Submissions Report

BERYL SOLAR FARM

JULY 2017

Project Number: 16-347

Figure 8-2 Updated Biodiversity Assessment Report Vegetation zones

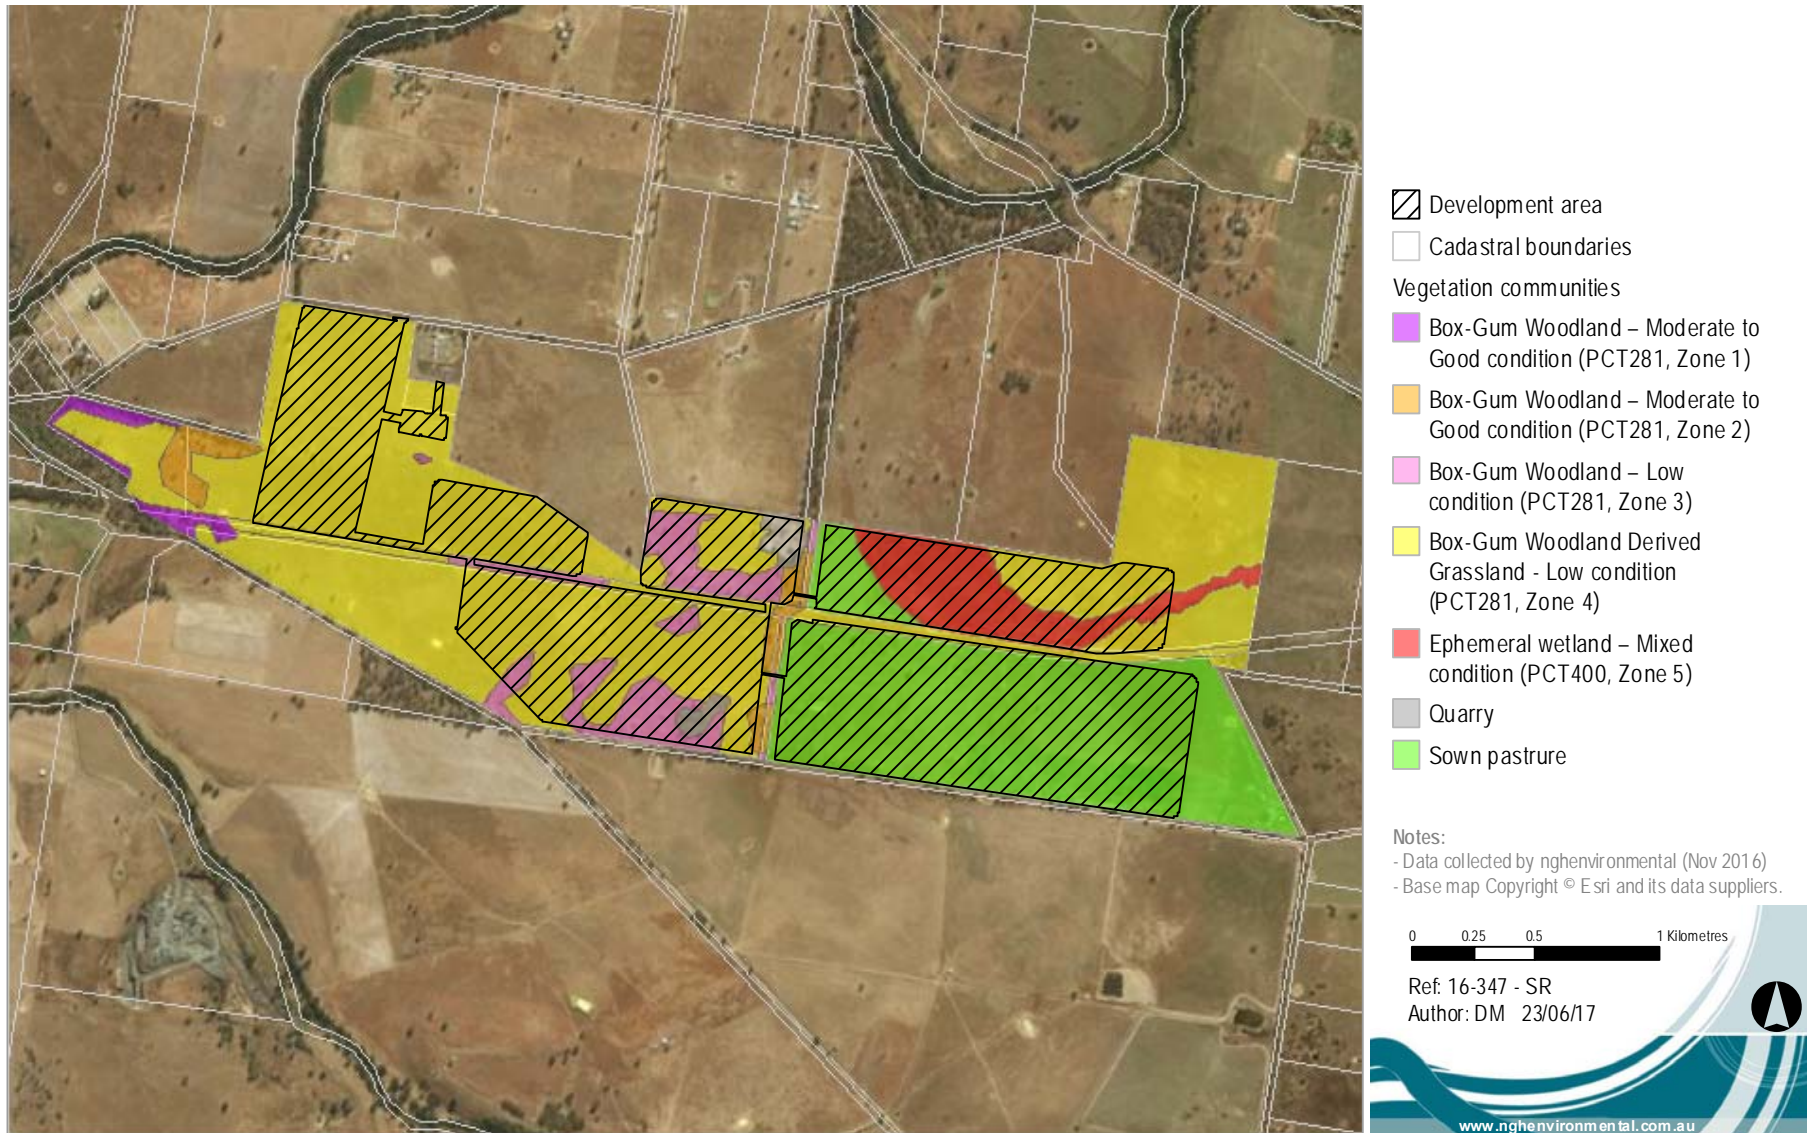
<h2>5.7 NSW ENVIRONMENTAL PROTECTION AUTHORITY</h2>		
<p>No comment</p>	<p>The NSW Environment Protection Authority (EPA) had previously determined that the proposed development is not a Scheduled Activity under the <i>Protection of the Environment Operations Act 1997</i> and consequently will not require an Environment Protection Licence. Therefore, they will not be reviewing or providing comment on the DA and EIS.</p>	<p>No changes to the EIS mitigation measures are considered to be required.</p>
<h2>5.8 NSW OFFICE OF ENVIRONMENT AND HERITAGE</h2>		
<p>Vegetation zones</p>	<p>The proponent has mapped five Box-Gum Woodland vegetation zones within the project site but has not provided details of the structural and/or floristic differences between the zones. OEH is unable to</p>	<p>Refer to Appendix I. The table provides a structural and floristic description of each of the vegetation zones, including notable differences between the zones. The table also identifies which zones are a threatened ecological community or not.</p>

Issue	Detail of issue	First Solar response
	<p>determine if the vegetation zones have been identified appropriately which may influence the number of credits generated by the project. The proponent should provide a structural and floristic description of each of the vegetation zones, including notable differences between the zones. Any other differences between the zones (e.g. soil type, past management, etc.) should also be described</p> <p>The BAR simply states whether each vegetation zone is a threatened ecological community or not. The BAR fails to detail why each vegetation zone in Table 3.2 does, or doesn't, form part of the White Box Yellow Box Blakely's Red Gum Woodland Endangered Ecological Community (EEC) listed on the <i>Threatened Species Conservation Act 1995</i> (TSC Act) or the White Box-Yellow Box-Blakely's Red Gum Grassy Woodland and Derived Native Grassland Critically Endangered Ecological Community (CEEC) listed on the <i>Environment Protection and Biodiversity Conservation Act 1999</i> (EPBC Act). The BAR does not provide comparison of the vegetation zones against the threatened ecological community listings. Details should be provided comparing the characteristics of the vegetation zones against the final determinations of the threatened ecological communities. OEH is unable to determine the appropriateness of the threatened ecological community mapping without further explanation by the proponent. Accurate identification of threatened ecological communities is critical as threatened ecological</p>	<p>No changes to the EIS mitigation measures are considered to be required.</p>
